Aero Engines SERVICE BULLETIN

Subject: Transmittal of Revision 1 to Service Bulletin Number V2500-NAC-78-0141

NACELLE - EXHAUST - ACTUATION SYSTEM HARNESS RE-ROUTE AND CLIPPING POINT HARDWARE REPLACEMENT

> MODEL APPLICATION V2500 - D5

Re-route T/R Actuation Harness & Replace Attach Hardware Figure 1

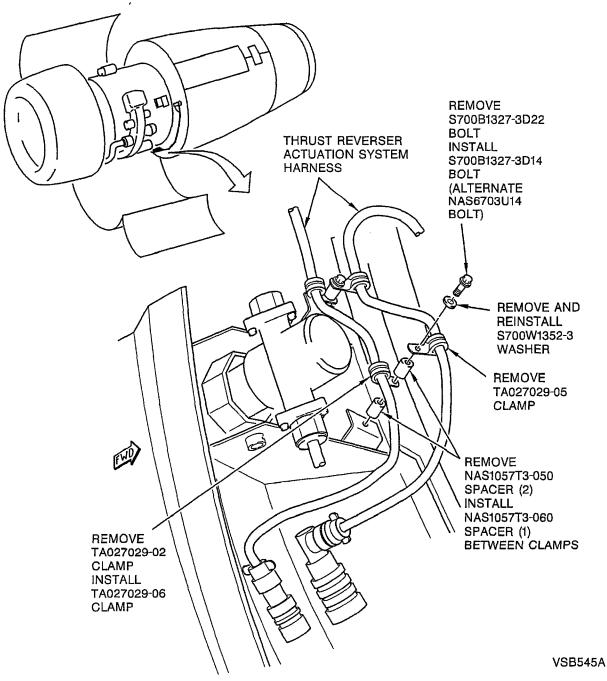
Interference may exist between the left hand lower thrust reverser half actuation system harness and the fuel flow meter mounted on the engine fan case.

Operators have experienced wear to the left hand lower thrust reverser half actuation system harness, P/N 6A6460, caused by interference with the engine fuel flow meter.

- B. Part 1 Examine the left hand lower thrust reverser actuation system harness, P/N 6A6460, near the engine fuel flow meter.
 - (1) If the actuation harness interferes with the fuel flow meter or if there is wear on either the harness or the fuel flow meter, you must inspect for damage/wear and then perform Part 2 of this Service Bulletin. Refer to Figure 1.

- (1) Remove the TA027029-05 clamp, TA027029-02 clamp, two NAS1057T3-050 spacers, and S700B1327-3D22 bolt from the clipping point. Discard the clamps, spacer and bolt. Keep the washers and nuts for installation. Refer to Figure 1.

- (2) Re-route the branch of the harness removed from the lower inboard discarded TA027029-05 clamp and install both branches of the harness into the TA027029-06 clamp (outboard position).

- (3) Install the S700B1327-3D14 bolt, NAS1057T3-060 spacer, and TA027029-06 clamp at the clipping point. Torque the bolt to 50-70 inch-pounds (5.6 -7.9 Nm).
